PCI-SIG ENGINEERING DRAFT CHANGE NOTICE

TITLE:	Flattening Portal Bridge (FPB)
DATE:	Introduced: 19 April 2016 Updated: 20 Oct 2016 PWG Approval: Member Review – 20 Oct 2016
AFFECTED DOCUMENT:	PCI Express Base Specification, Rev. 3.0 / 3.1
SPONSOR:	Intel, Microsoft, NVidia

Figure 6-x1: FPB High Level Diagram and Example Topology

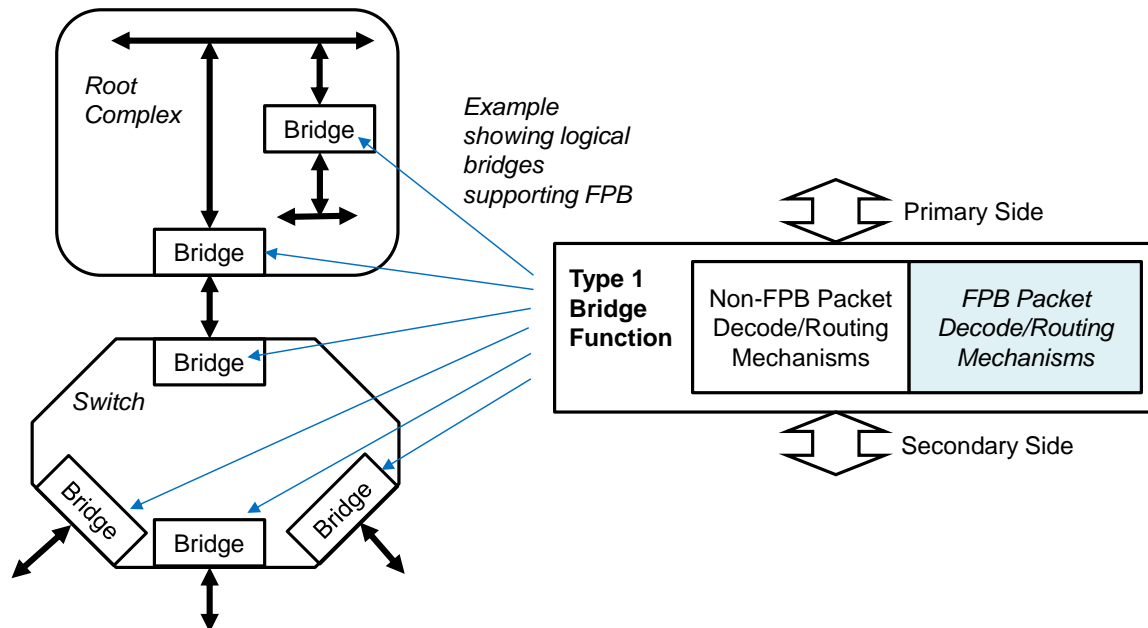
A Bridge that implements the FPB capability can itself also be referred to as an FPB. The FPB capability can be applied to any logical bridge, as illustrated in <Figure 6-x1>.

Figure 6-x1a: Example Illustrating "Flattening" of a Switch

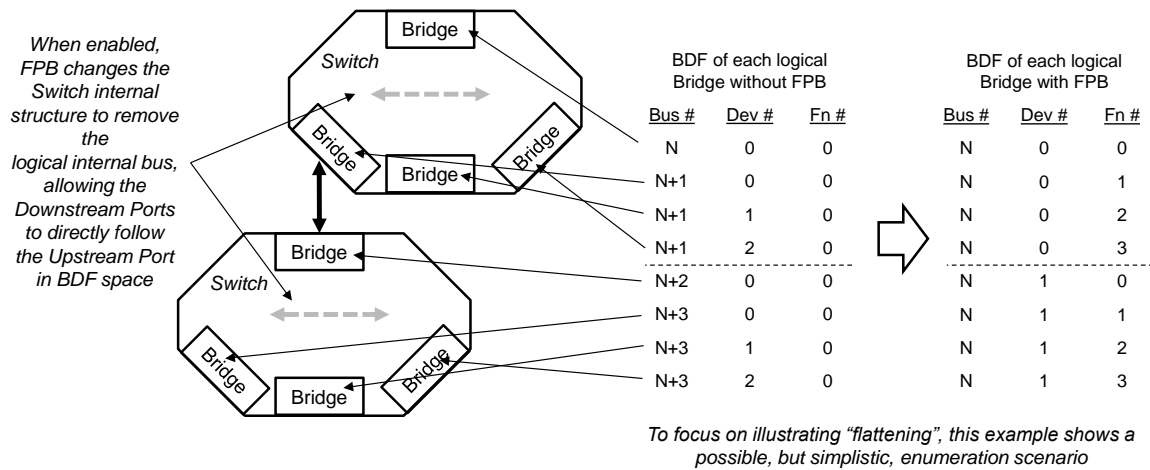
FPB changes the way Bus Numbers are consumed by Switches to reduce waste, by “flattening” the way Bus Numbers are used inside of Switches and by Downstream Ports (Figure 6-x1a).

Figure 6-x1b: Vector Mechanism for Address Range Decoding

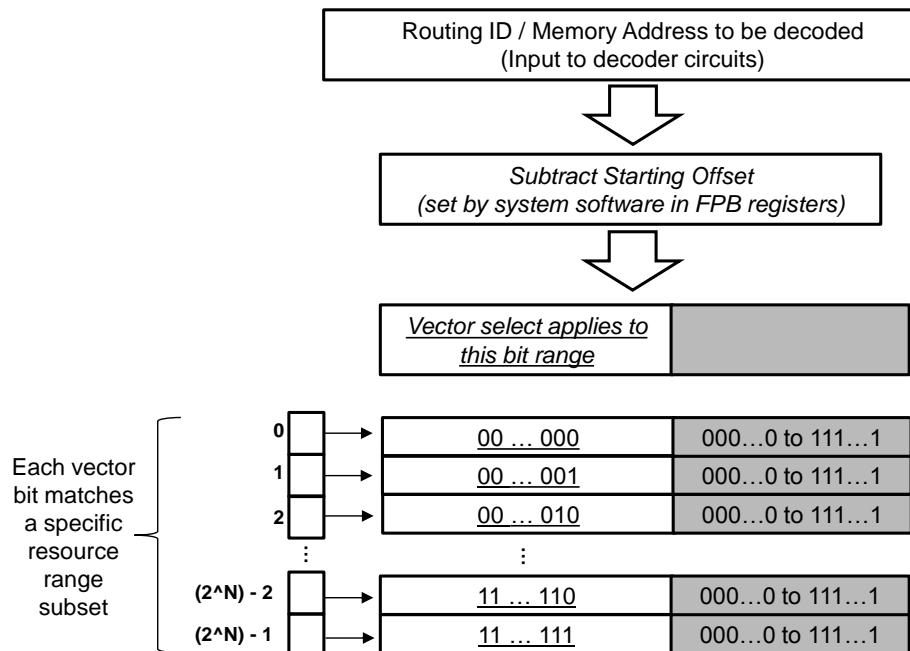
FPB defines mechanisms for system software to allocate Routing IDs and Memory Space resources in non-contiguous ranges, enabling system software to assign pools of these resources from which it can allocate "bins" to Functions below the FPB. This is done using a bit vector where each bit when Set assigns a corresponding range of resources to the Secondary Side of the Bridge (see Figure 6-x1b).

Figure 6-x2: Relationship between FPB and non-FPB Decode Mechanisms

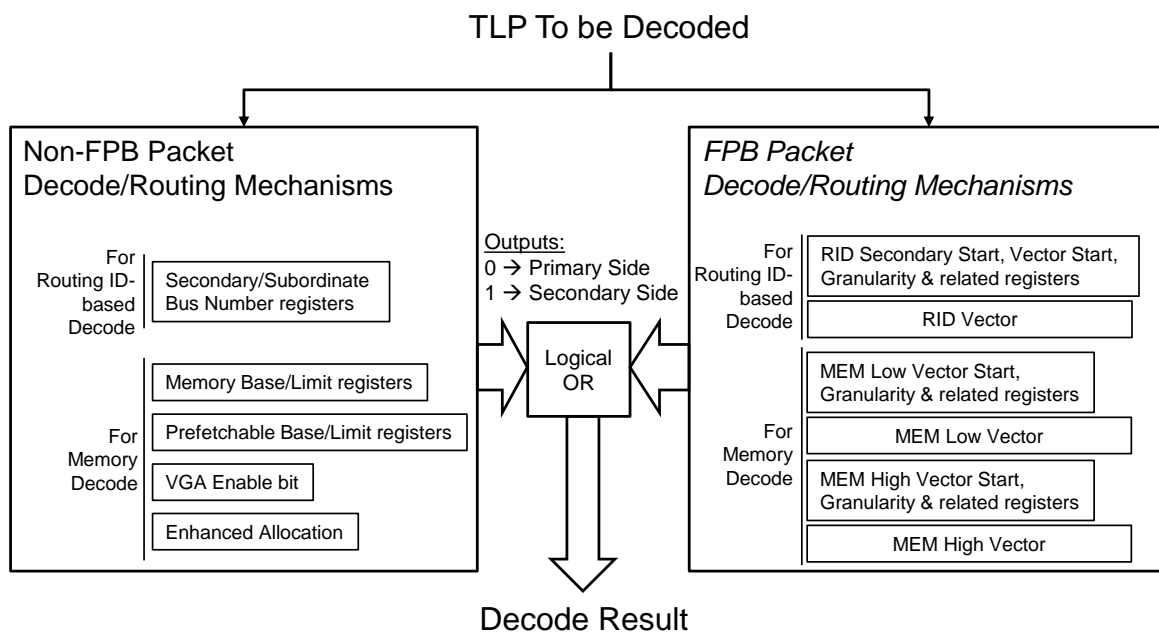
FPB is defined to allow both the non-FPB and FPB mechanisms to operate simultaneously, such that, for example, it is possible for system firmware/software to implement a policy where the non-FPB mechanisms continue to be used in parts of the system where the FPB mechanisms are not required (see Figure 6-x2). In this figure, the decode logic is assumed to provide a ‘1’ output when a given TLP is decoded as being associated with the bridge’s Secondary Side. The non-FPB decode mechanisms apply as without FPB, so for example only the Bus Number portion (bits 15:8) of a Routing ID is tested by the non-FPB decode logic when evaluating an ID routed TLP.

Figure 6-x3: Routing IDs (RIDs) and Supported Granularities

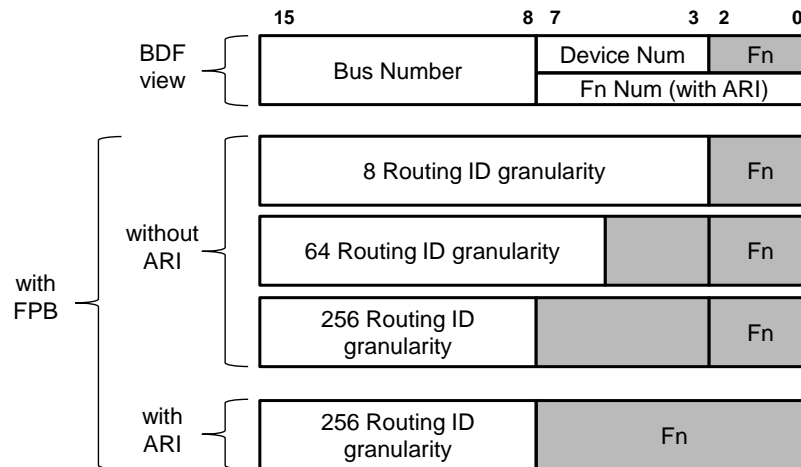
When ARI is not enabled, The FPB RID mechanism can be applied with different granularities, programmable by system software through the FPB RID Vector Granularity register in the FPB RID Vector Control 1 Register. Figure 6-x3 illustrates the relationships between the layout of RIDs and the supported granularities. The reader may find it helpful to refer to this figure when considering the requirements defined below and in the definition of the Flattening Portal Bridge (FPB) Capability (Sect. 7.y).

Figure 6-x2: Addresses in Memory Below 4GB and Effect of Granularity

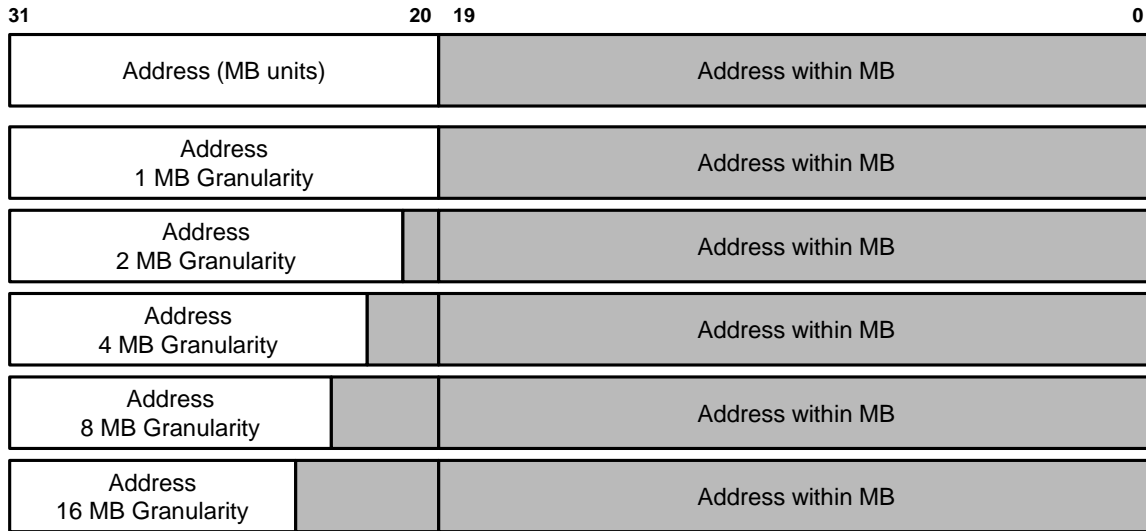
The FPB MEM Low mechanism can be applied with different granularities, programmable by system software through the FPB MEM Low Vector Granularity register in the FPB MEM Low Vector Control Register. Figure 6-x4 illustrates the relationships between the layout of addresses in the memory address space below 4GB to which the FPB MEM Low mechanism applies. The reader may find it helpful to refer to this figure when considering the requirements defined below and in the definition of the Flattening Portal Bridge (FPB) Capability (Sect. 7.y).

Figure 7-y2: FPB Capability Register

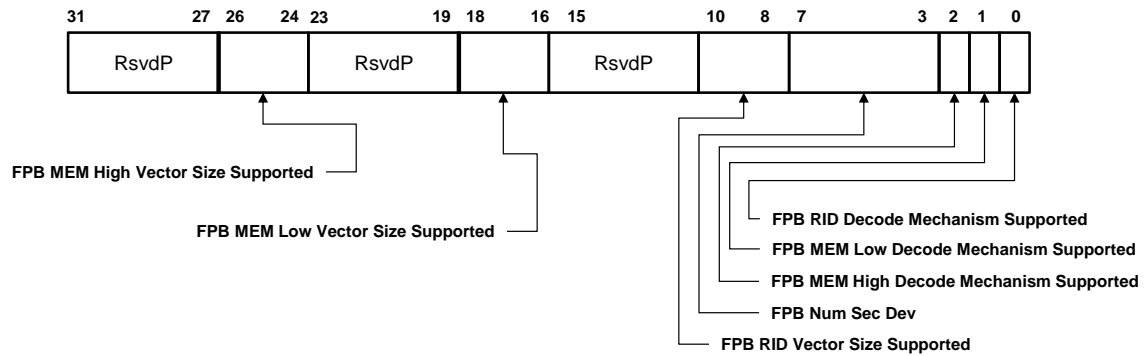
Bit Location	Register Description	Attributes												
0	FPB RID Decode Mechanism Supported – If Set, indicates that the RID Vector mechanism is supported.	RO												
1	FPB MEM Low Decode Mechanism Supported - If Set, indicates that the MEM Low Vector mechanism is supported.	RO												
2	FPB MEM High Decode Mechanism Supported - If Set, indicates that the Mem High mechanism is supported.	RO												
7:3	<p>FPB Num Sec Dev - For Upstream Ports of Switches only, this field indicates the quantity of Device Numbers associated with the Secondary Side of the Upstream Port Bridge. The quantity is determined by adding one to the numerical value of this field.</p> <p>Although it is encouraged that Switch implementations assign Downstream Ports using all 8 allowed Functions per allocated Device Number, such that all Downstream Ports are assigned within a contiguous range of Device and Function Numbers, it is, however, explicitly permitted to assign Downstream Ports to Function Numbers that are not contiguous within the indicated range of Device Numbers, and system software is required to scan for Downstream Port Bridges at every Function Number within the indicated quantity of Device Numbers associated with the Secondary Side of the Upstream Port. This field is Reserved for Downstream Ports.</p>	RO/RsvdP												
10:8	<p>FPB RID Vector Size Supported – Indicates the size of the FPB RID Vector implemented in hardware, and constrains the allowed values software is permitted to write to the FPB RID Vector Granularity field.</p> <p>Defined encodings are:</p>

Figure 7-y3: FPB RID Vector Control 1 Register

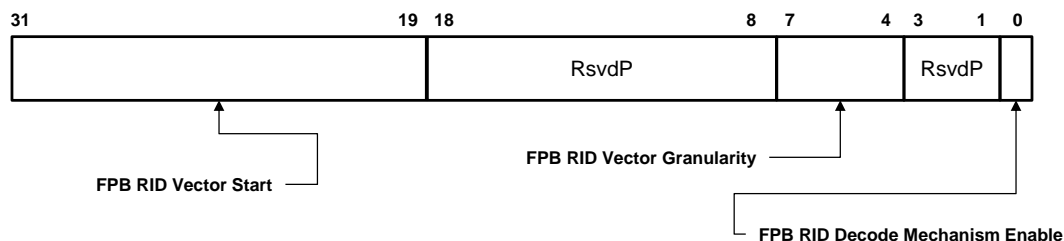
Bit Location	Register Description	Attributes								
0	FPB RID Decode Mechanism Enable – When Set, enables the FPB RID Decode Mechanism If the FPB RID Decode Mechanism Supported bit is Clear, then it is permitted for hardware to implement this bit as RO, and in this case the value in this field is undefined. Default value of this bit is 0b.	RW/RO								
3:1	Reserved	RsvdP								
7:4	FPB RID Vector Granularity – The value written by software to this field controls the granularity of the FPB RID Vector and the required alignment of the FPB RID Vector Start field (below). Defined encodings are:

Figure 7-y5: FPB MEM Low Vector Control Register

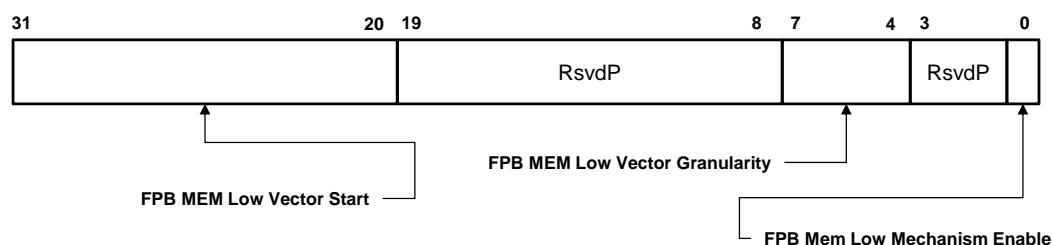
Bit Location	Register Description	Attributes
0	FPB MEM Low Decode Mechanism Enable - When Set, enables the FPB MEM Low Decode mechanism. If the FPB MEM Low Decode Mechanism Supported bit is Clear, then it is permitted for hardware to implement this field as RO, and in this case the value in this field is undefined. Default value of this bit is 0b.	RW/RO
3:1	Reserved	RsvdP

Figure 7-y6: FPB MEM High Vector Control 1 Register

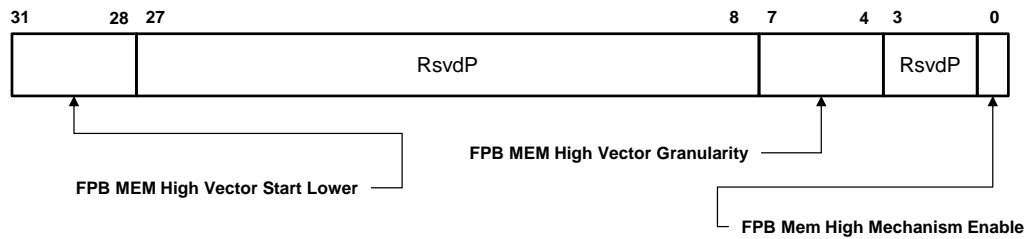
Bit Location	Register Description	Attributes
0	FPB MEM High Decode Mechanism Enable - When Set, enables the FPB MEM High Decode mechanism. If the FPB MEM High Decode Mechanism Supported bit is Clear, then it is permitted for hardware to implement this field as RO, and in this case the value in this field is undefined. Default value of this bit is 0b.	RW/RO
3:1	Reserved	RsvdP

Figure 7-y7: FPB MEM High Vector Control 2 Register

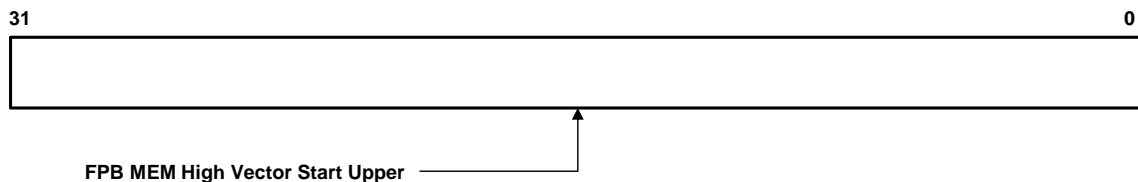
31:0	<p>FPB MEM High Vector Start Upper – The value written by software to this field indicates bits 63:32 of the base address at which the FPB MEM High Vector is applied. If the FPB MEM High Decode Mechanism Supported bit is Clear, then it is permitted for hardware to implement this field as RO, and the value in this field is undefined. Default value for this field is 0000_0000h.</p>	RW/RO
------	---	-------

Figure 7-y8: FPB Vector Access Control Register

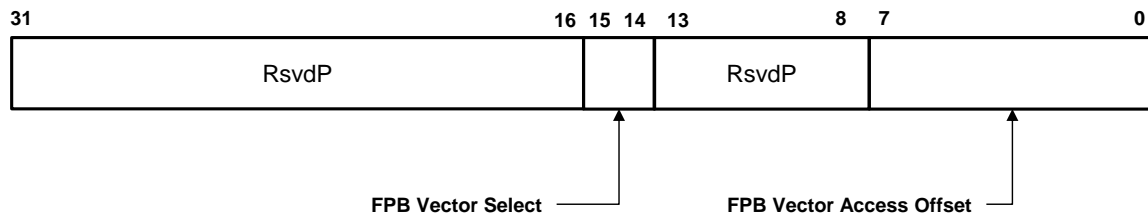
7:0	<p>FPB Vector Access Offset – The value in this field indicates the offset of the 32b portion of the FPB BD, MEM Low or MEM High, Vector that can be read or written by means of the FPB Vector Access Data Register. The selection of BD, MEM Low or MEM High is made by the value written to the FPB Vector Select field of this register.</p> <p>The bits of this field map to the offset according to the value in the corresponding FPB Vector Size Supported field as shown here:</p>

Figure 7-y9: FPB Vector Access Data Register

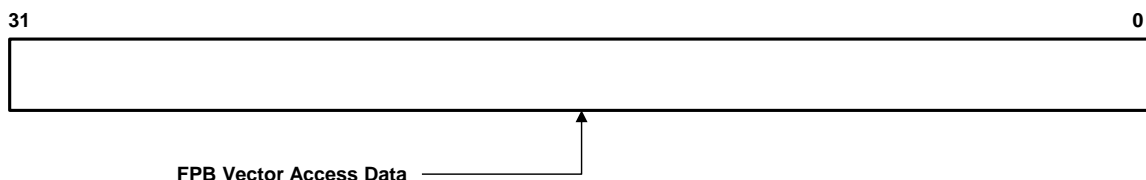
Bit Location	Register Description	Attributes
31:0	FPB Vector Access Data – Reads from this register return the DW of data from the FPB Vector at the location determined by the value in the FPB Vector Access Offset Register. Writes to this register replace the DW of data from the FPB Vector at the location determined by the value in the FPB Vector Access Offset Register. Default value for this field is 0000h	RW
